FINAL Environmental Impact Statement Newmont Mining Corporation's South Operations Area Project Amendment

Appendix E Public Comment Letters and Responses

RESPONSES TO PUBLIC COMMENTS ON SOAPA DEIS

Figure 1: Flow increases from the Maggie Creek canyon to the confluence with the Humboldt River. The hydrograph was determined taking the difference between recorded flows at USGS gaging stations.

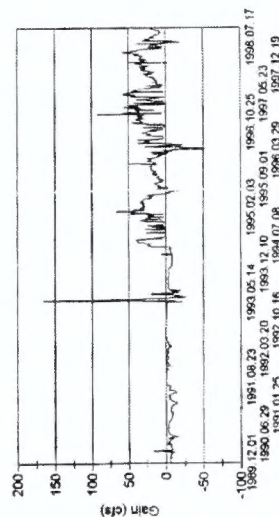
Discharges to Maggie Creek: There is an acknowledgment that Newmont discharges to Maggie Creek, but there is little detailed discussion. Prior

to dewatering discharge, Maggie Creek lost 3.2 cfs from the canyon to the Humboldt River (Figure 1). With dewatering, it gains 19.8 cfs (Figure 1). These losses are averages calculated without removing the spikes caused by obvious local storm inflows. The total contribution of Newmont to the discharge into the Humboldt River between April 25, 1994 and September 30, 1998 is 23 cfs (actually a little less due to several isolated flood inflows).

Figure 1: Computed head levels with time for the 15 layers.

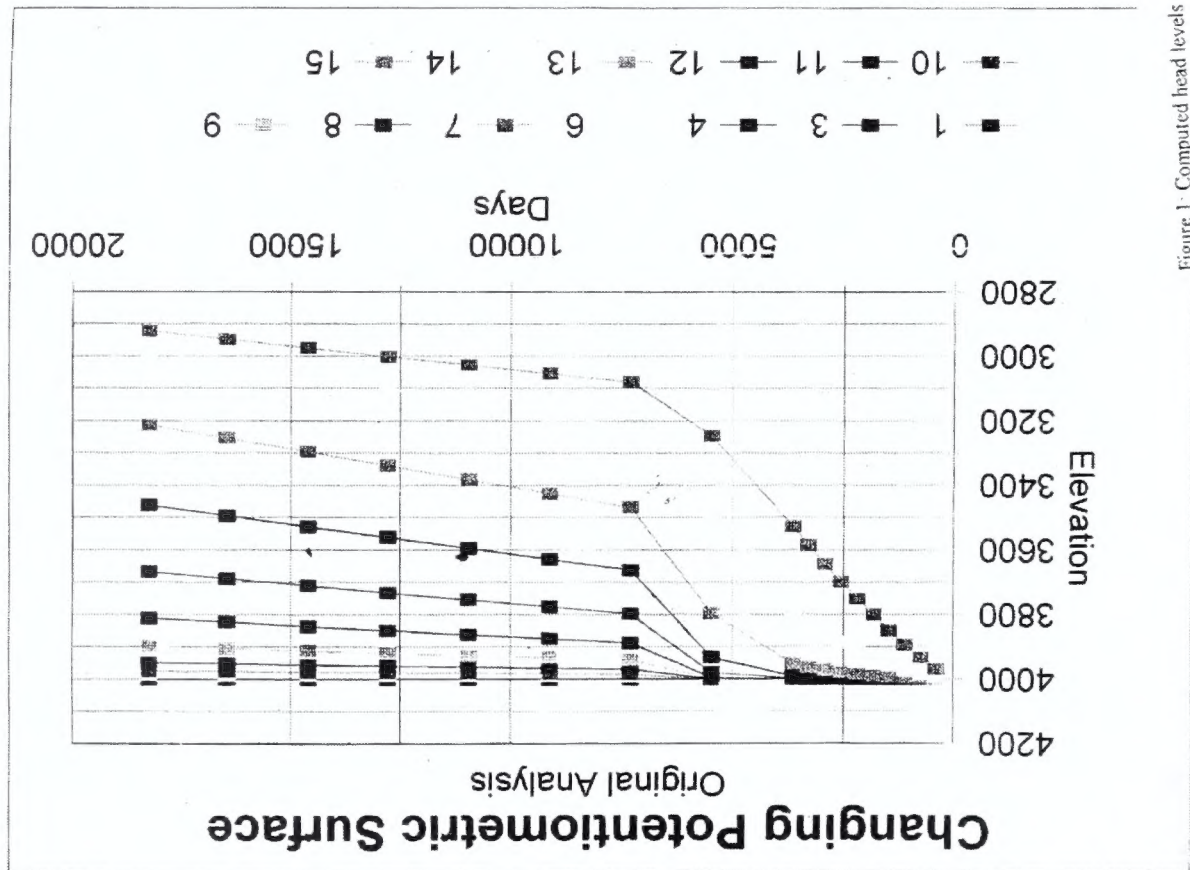
Figure 1 shows the changing potentiometric surface in most layers. Clearly, the lower layer, with $K=10$ ft/d, depressurizes quickly and almost reaches 2900' by the end of the scenario. This reflects the expanding dewatering cone into the bedrock beneath the Carlin formation. The lower clay layers also draw down substantially, but the upper layers barely change at all. The upper layer 4 actually increases initially as recharge infiltrates into it before lowering to only 3999 (Figure 2). There is only a one-foot drawdown in the uppermost clay layer after 61 years of stress. The top layer shows a modest (less than 0.5 foot) increase in head due to mounding recharge.

Figure 3. Various model fluxes with time.

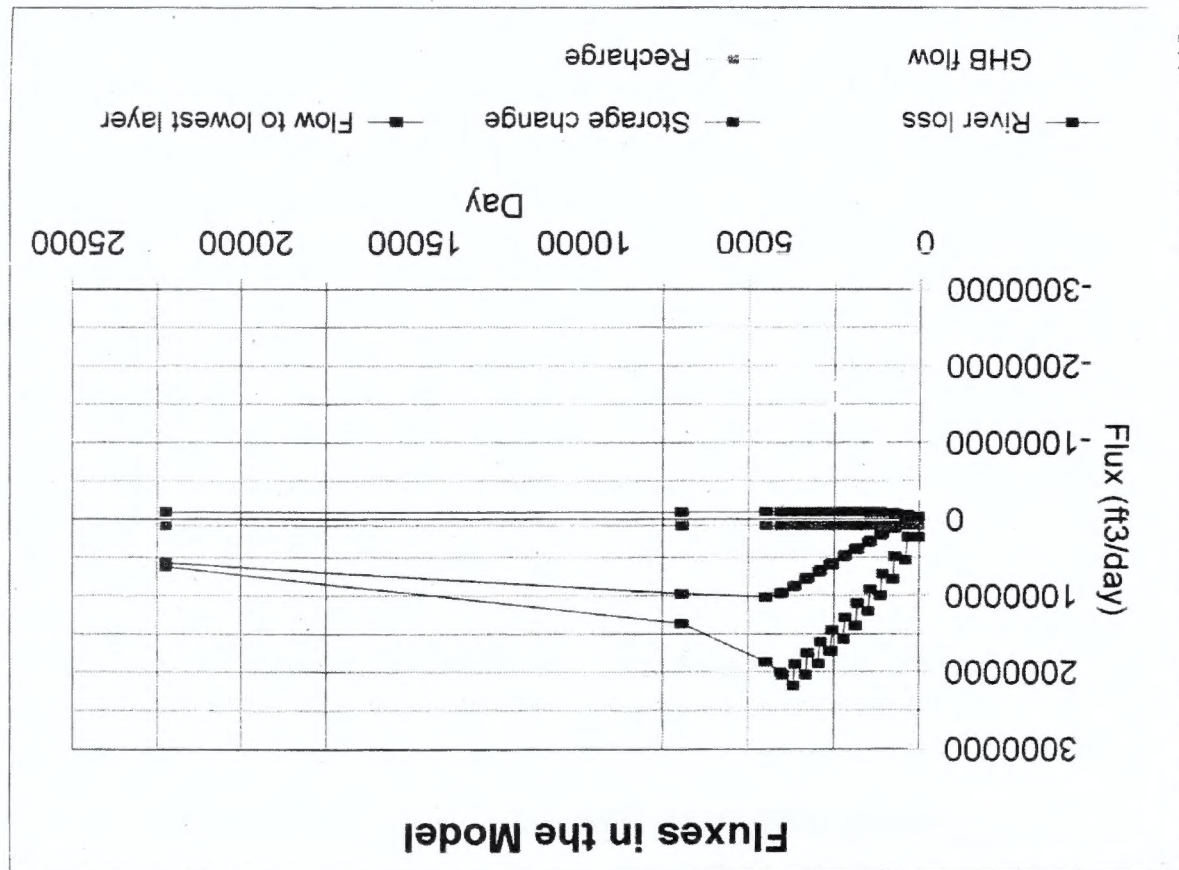
Because there is no drawdown in the upper layers there is no change in flux to the river (Figure 3). The GHB flux increases to 1,000,000 ft³/day after 4500 days. This is the time that the GHB reaches the maximum depth. After that, the flux decreases as the cone expands and the gradient at the GHB decreases. Total recharge equals about 89,000 ft³/day; flux to the river fluctuates around this value. Recharge does not go to satisfying the GHB demand.

Storage releases satisfy most of the GHB demand which almost mirrors the GHB flows (Figure 3). Initially, most the storage release is in the lower layer but eventually flow to layer 15 equals about half of the GHB flux at the point where maximum stress is reached. As indicated by the increase in flow to the lower layer by the end of the model run, most GHB flux is from upper layers (Figure 3). Based on the fact that recharge just cycles to the river, this is mostly releases from the clay layers. This is also reflected in the changes occurring in the potentiometric surface of the lower clay layers.

Figure 4. Effects of increasing the conductivity of the clay by amounts shown in the legend on the flow to the GHB

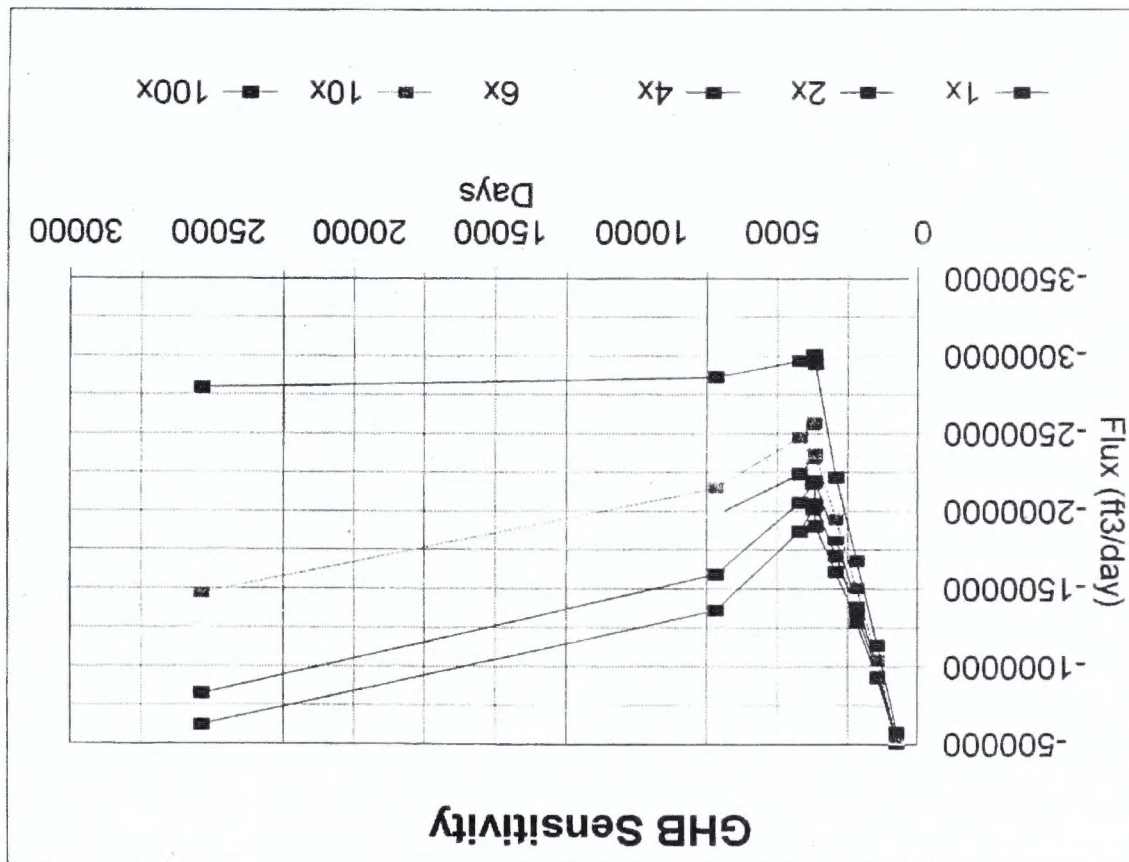
Increasing the clay layer conductivity increases the GHB flux (Figure 4). At the point that the maximum stress (GHB reaches 2900' after 11 years) begins the range in flux is only about 1,100,000 ft³/day. The flux decreases quicker for low conductivity values. Flux remains higher than 2,750,000 ft³/d for the $100\times$ Kh value analysis. The tendency to higher fluxes as clay layer conductivity increases drives increased flow through the layers (Figure 5). After the complete 61 year run, a steady flux of 2,800,000 ft³/d was occurring through all layers for the $100\times$ Kh scenario. For the other scenarios, the vertical flux was still becoming established. None of the upper layers had established vertical flux in excess of recharge by 61 years; flux for the original condition was essentially 0. This indicates that many years could pass before dewatering of the lower layer affects the upper layer. More importantly, only a two orders of magnitude change will cause a complete change in vertical flux over a 61 year period.

Figure 6 Change in total model storage for changes in clay layer conductivity as shown in the legend.

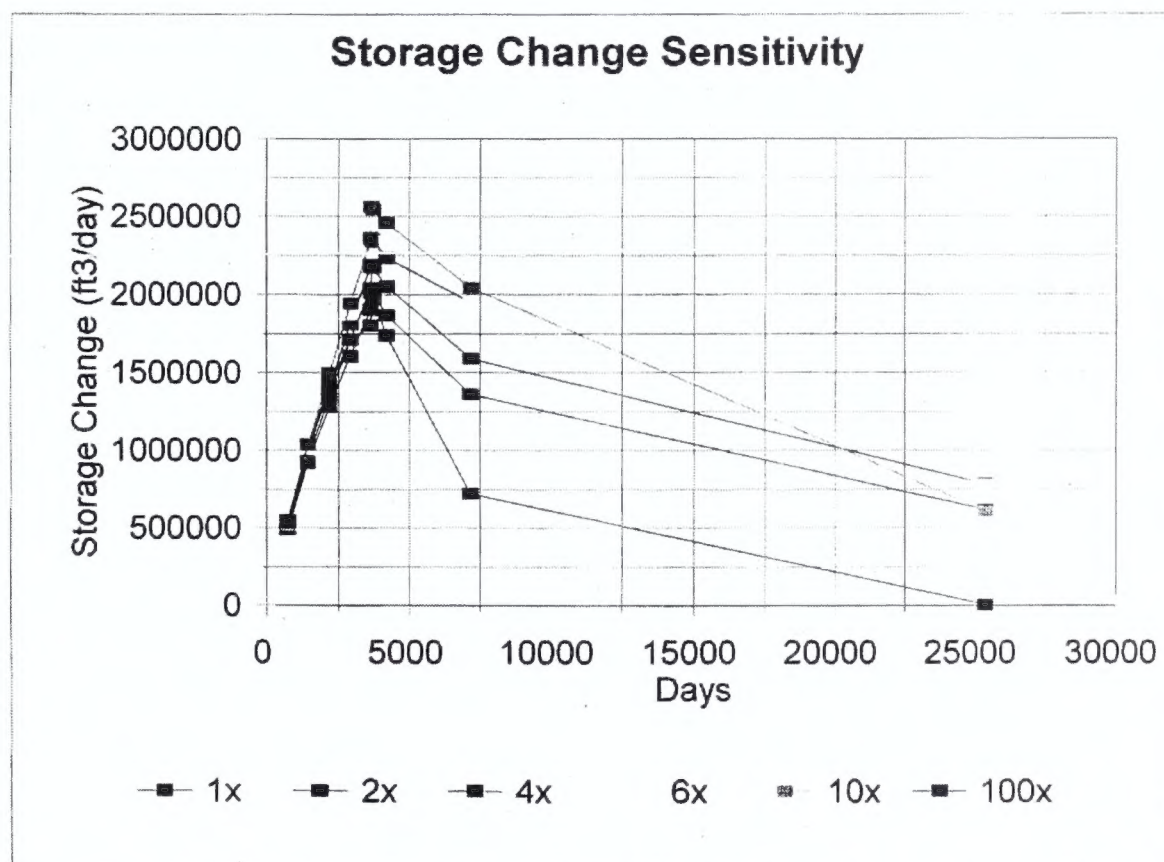
Releases from storage are more complicated (Figure 6). With clay layer conductivity increasing to $10\times$ Kh, initial storage releases increase from 1,600,000 to 2,500,000 ft³/d after 11 years. For the $100\times$ Kh scenario, storage releases are initially high, but rapidly drop. This reflects the propagation of a gradient through the layers and the contribution of recharge to the vertical flux between layers. Thus, the amount of

Figure 7: Change in river flux for changes in clay layer conductivity as shown in the legend.

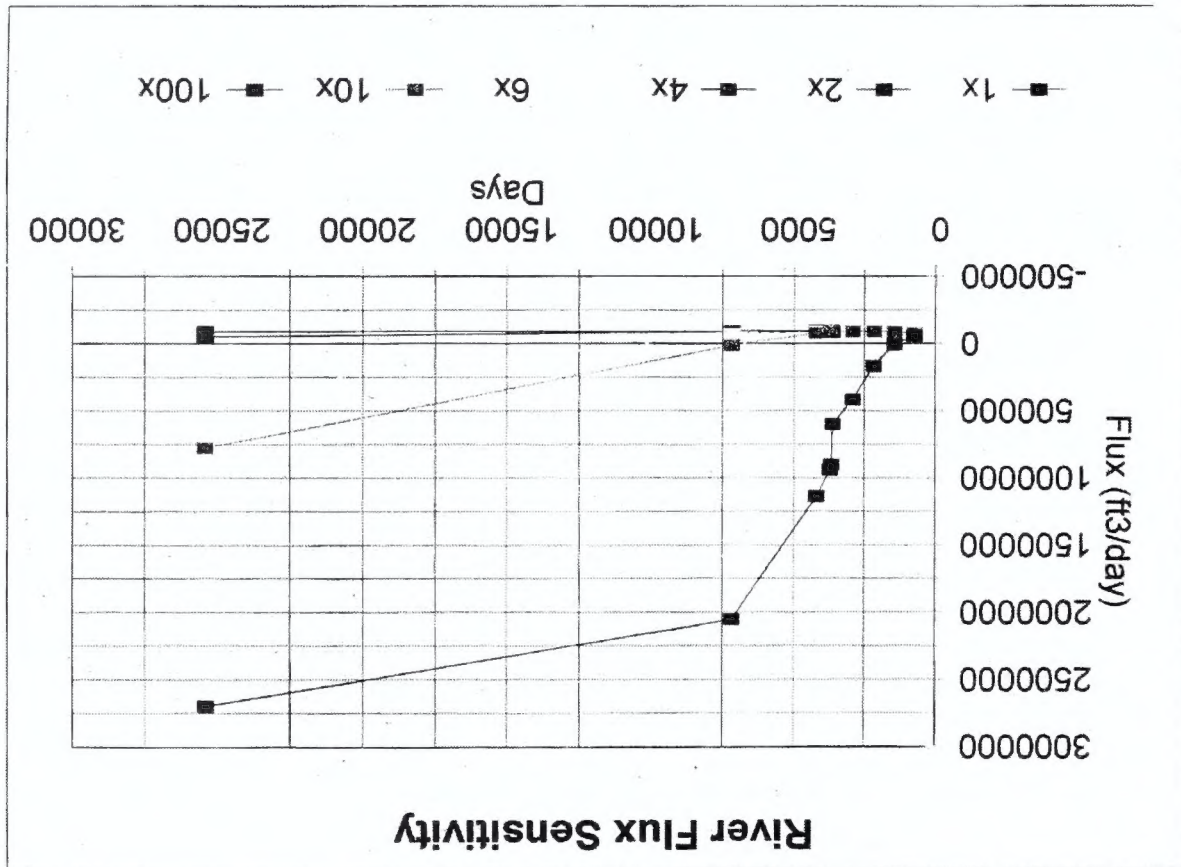
water released from storage decreases as the vertical gradient allows water to be drawn from the river (Figure 7).

River flux is much higher for $10\times$ and $100\times$ Kh, but even the $2\times$ Kh scenario causes substantial changes to the river flux (Figure 7). Only for the original Kh, 0.00001 ft/d, does river flux remain unchanged. More than 7000 days (19 years) are required until a breakthrough occurs where impacts to the river occur for all scenarios up to $10\times$ Kh.

Figure 8: Change in flow to layer 15 for changes in clay layer conductivity as shown in the legend

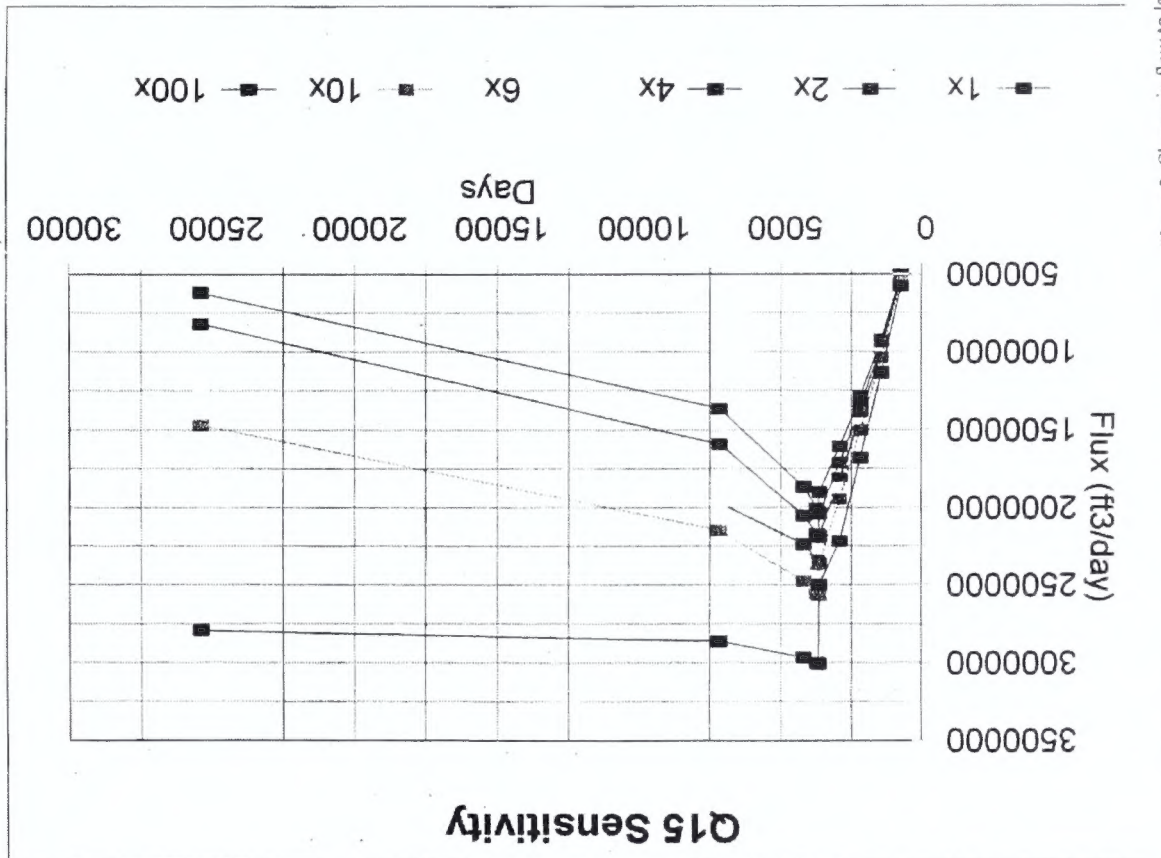
Flow into the lower layer peaks at the time that the maximum stress is applied and begins to fall thereafter (Figure 8). The rate of fall is highest for the original conductivity because the drawdown cone expands, the gradient to the GHB decreases and the total flux to the GHB also decreases. There is a sharp increase in vertical flux at the lower layers for the original conductivity at 4200 days (Figure 9). As time advances, flow to the lower layer decreases, but vertical flow begins in higher clay layers.

Figure 24. GHB flux for the original scenario and three gravel in clay layer scenarios.

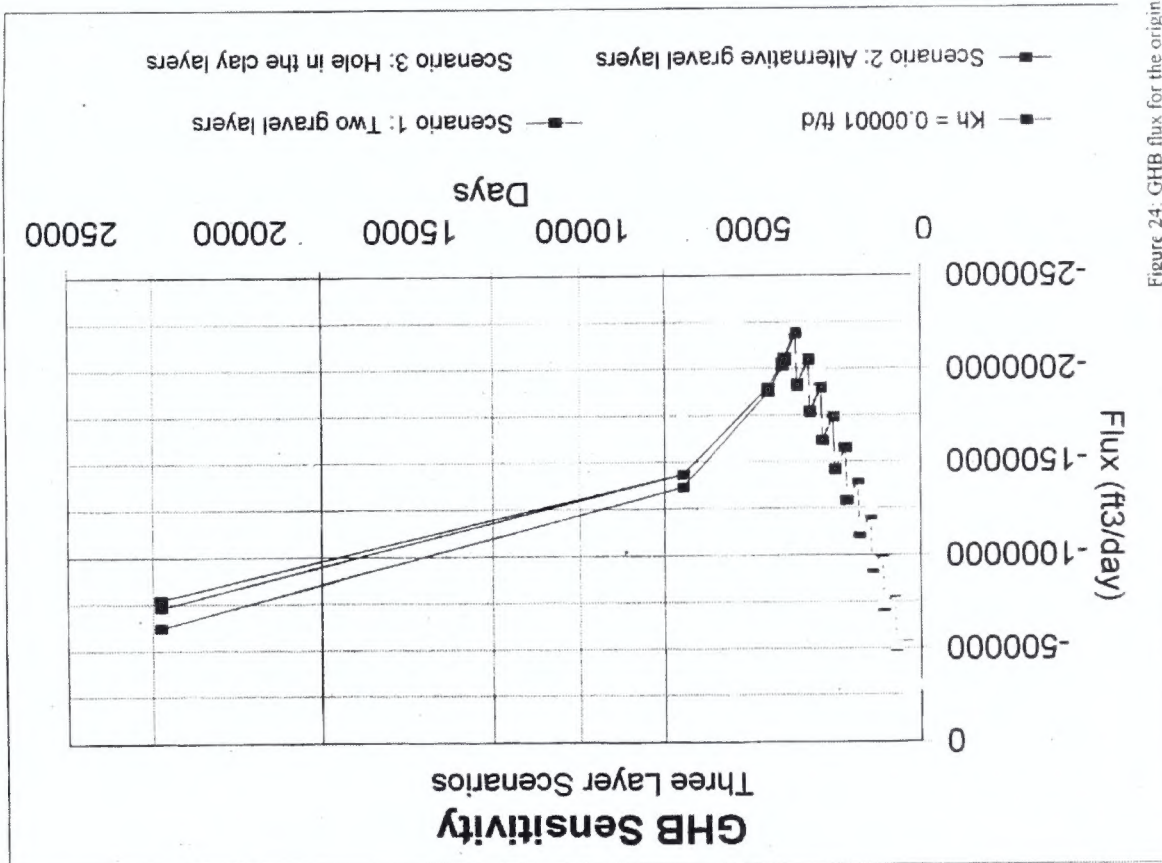
For most of the model run, scenarios 1 and 2 had a less than 5% effect on the flow to the GHB boundary (Figure 24). The lack of difference between scenario 1 and 2 as opposed to both of their differences from the original scenario suggests that the mere presence of gravel in the clay layer increases flow from the system, especially in later years. Scenario 3 almost doubled the flow from the system. However, the "hole" in the clay layer in this scenario is quite large which suggests that this scenario is an upper limit to the impacts of a hole. However, the increased flows (for any scenario) do not really begin until day 4000.

Figure 26: Flow to layer 15 for the original scenario and three gravel in clay layer scenarios.

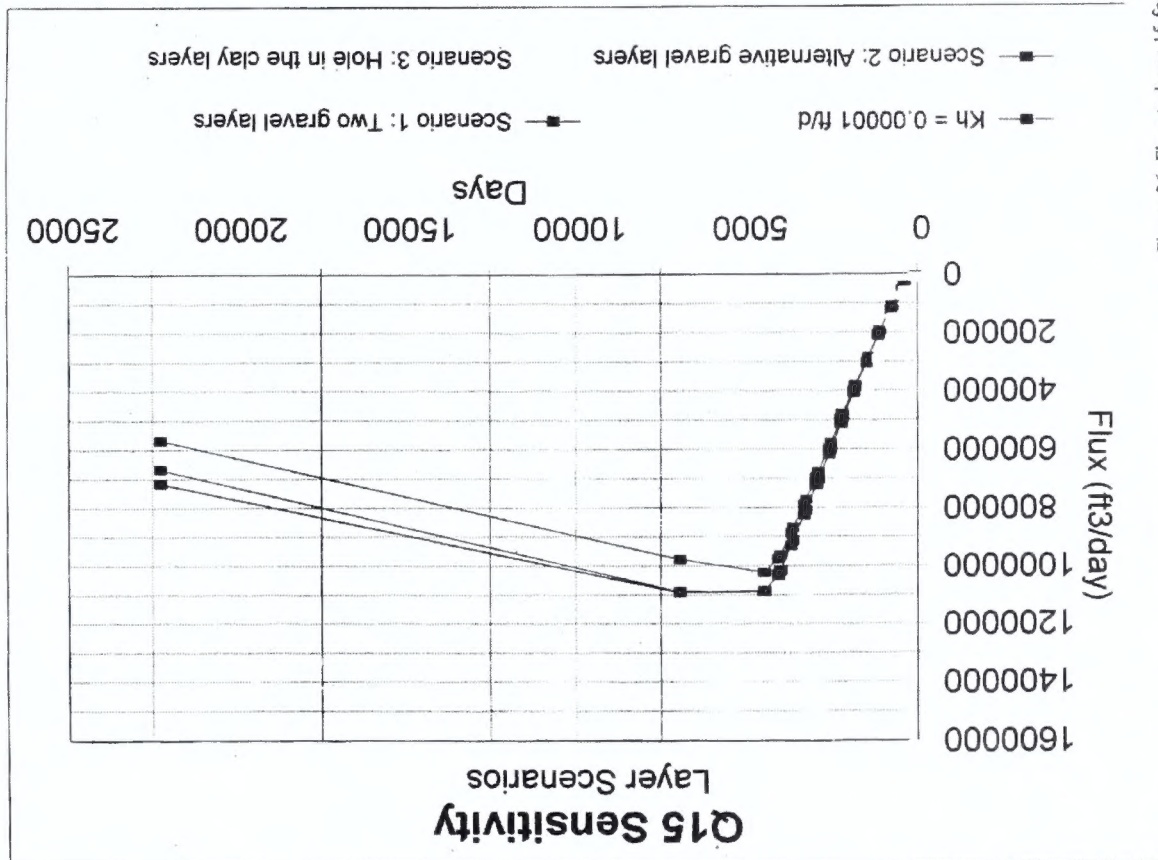
Initially, flow to layer 15 (Figure 26) is about one-half the flow to the GHB (Figure 24). In the long run, scenario 3 has almost reached steady state with flow to layer 15 equaling flow from the system. Flow to layer 15 lags flow from the system in the two gravel layer scenarios by about 25%. The hole allows steady state to be reached sooner with increased flow from upper layers but less drawdown in lower layers.

Figure 27. River flux for the original scenario and three gravel in clay layer scenarios.

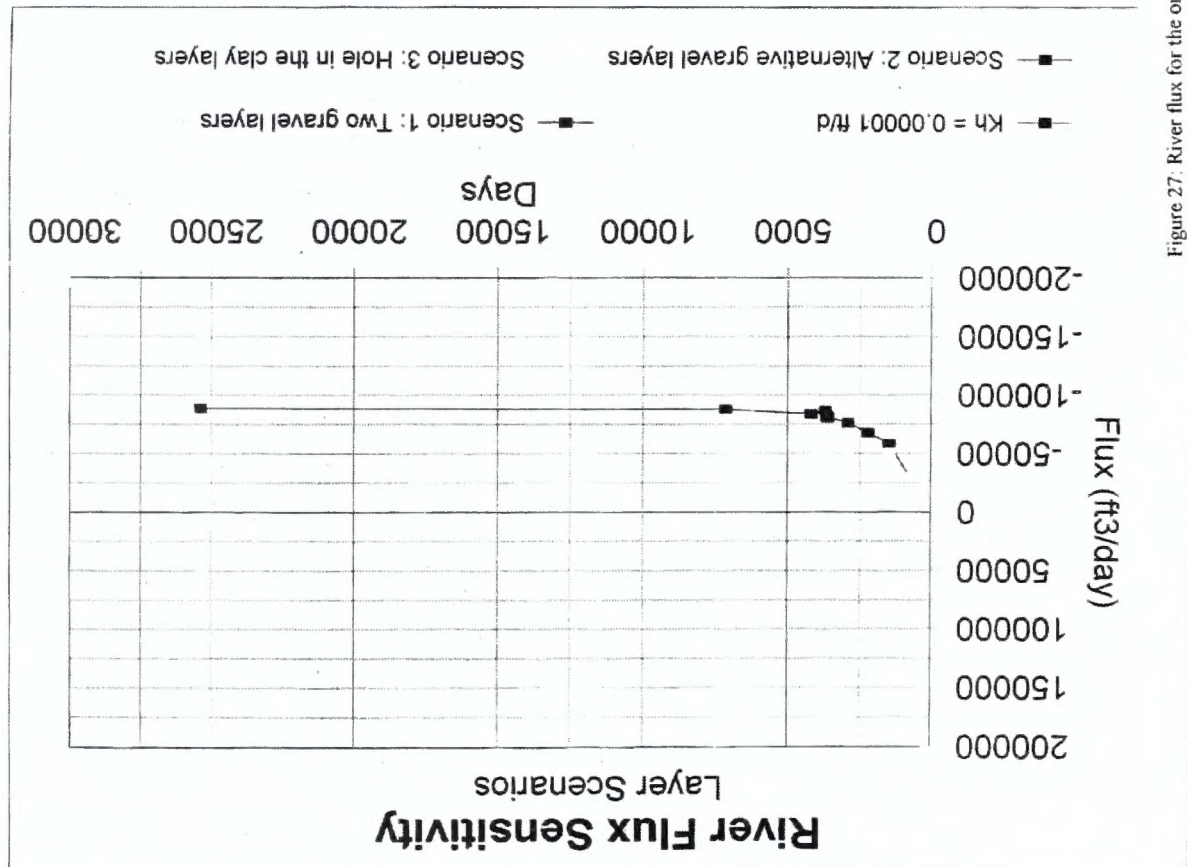
Adding gravel layers to the clay layer had essentially no effect on flux from the river. The increased flow through the hole causes almost a 150,000 ft³/day loss to the river (Figure 27).
